Please can you provide me with a list of what information (relevant to the planning application) you consider to be inaccurate or requires updating, together with evidence to demonstrate why you believe this to be the case?

Figure 4-3 FN Frequency-Consequence Chart plot of societal risk

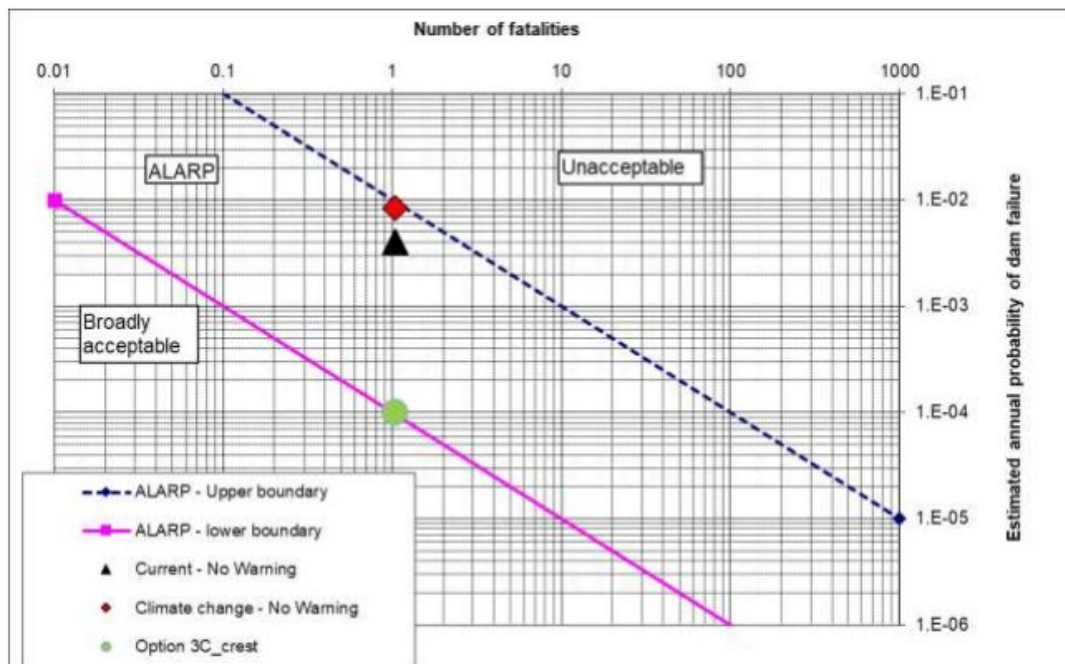
Section 1.4 and 1.5 of the Summary Options Report states that the risk of loss of life and property damage to those living downstream is unacceptably high. However, the Jacobs Initial Options report had to be amended following the discovery by Friends of Poynton Pool of a significant error showed that the risk was not in the

unacceptable zone but actually in the As Low as Reasonably Practicable (ALARP) region. Please see below
